**ADDRESS: 602 S FRONT ST**

Proposal: Construct shed dormer and replace front windows

Review Requested: Final Review

**STAFF RECOMMENDATION:** Denial, pursuant to Standards 2 and 9.

**A-100**

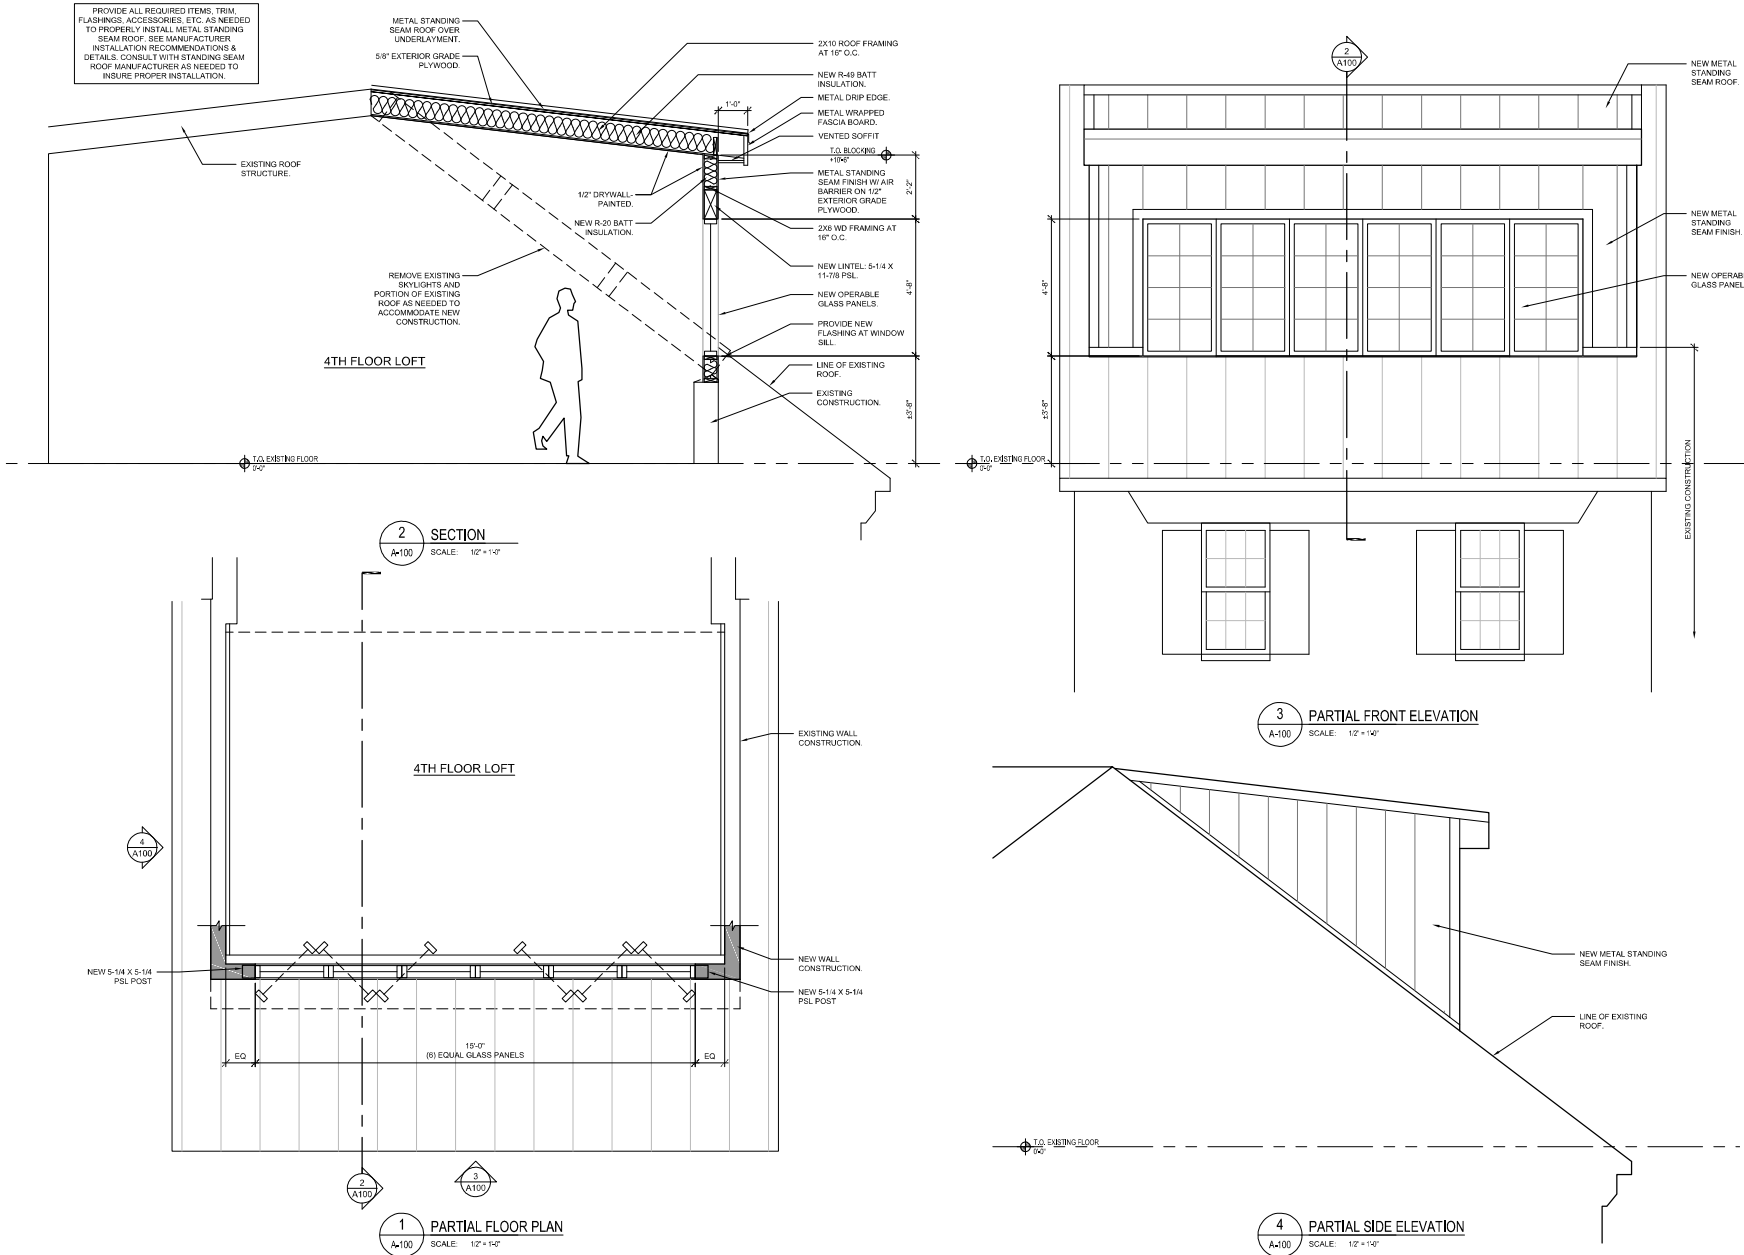
- Although the existing front dormer is clad in glass, it maintains its historic form and proportions. Removal of the front dormer does not meet Standard 2.

- The proposed shed dormer would be highly visible, and the proposed design and materials are incompatible with the late eighteenth-century house. Therefore, it does not meet Standard 9.

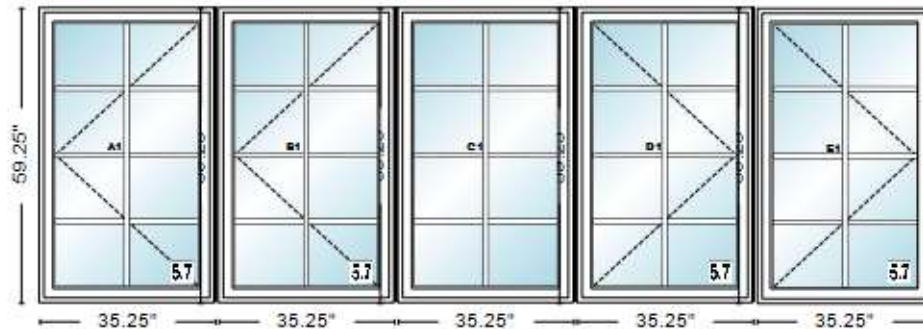
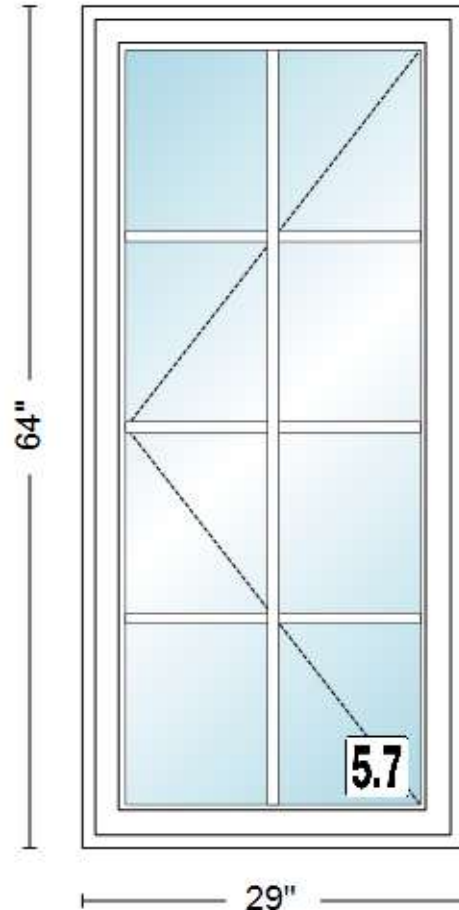
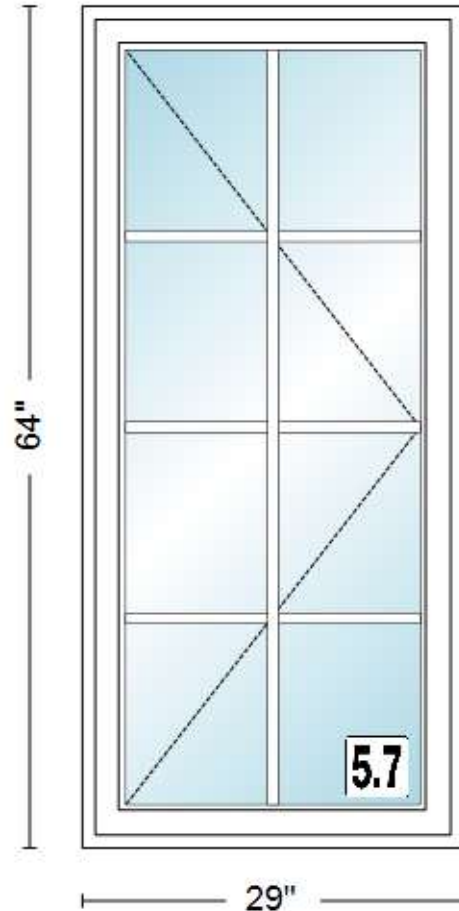
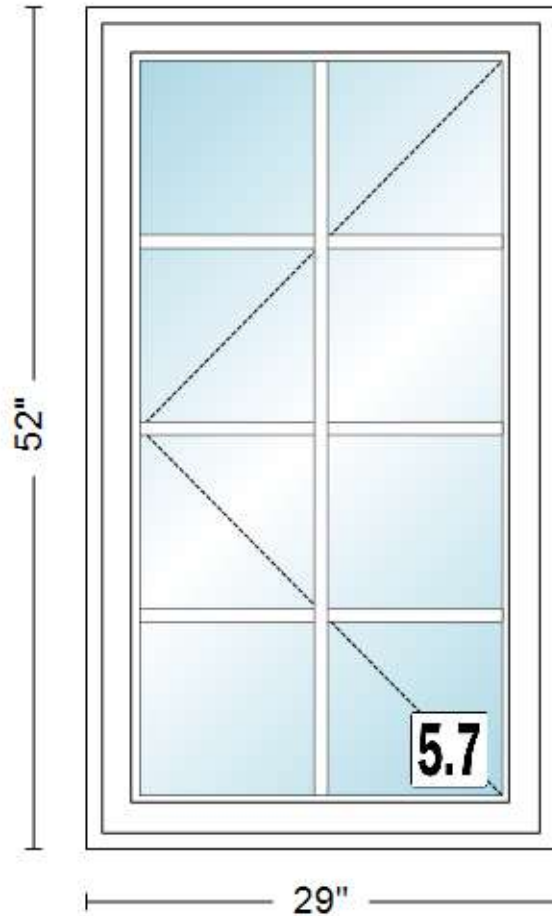
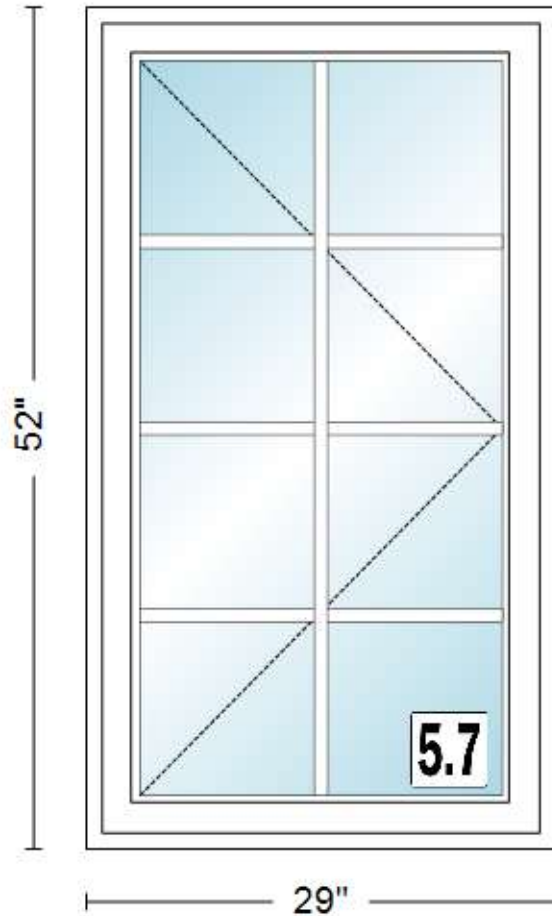
- Removal of the double-hung windows from the front façade and replacing them with casement windows does not meet Standard 2.
- *Standard 9: New additions, exterior alterations, or related new construction shall not destroy historic materials that characterize the property. The new work shall be differentiated from the old and shall be compatible with the massing, size, scale, and architectural features to protect the historic integrity of the property and its environment.*

- The four front windows on the second and third floor are not original and can be replaced in kind with new double-hung wood windows. An in-kind replacement would meet Standard 9. The current proposal to replace the historically accurate windows with casement windows does not meet Standard 9.
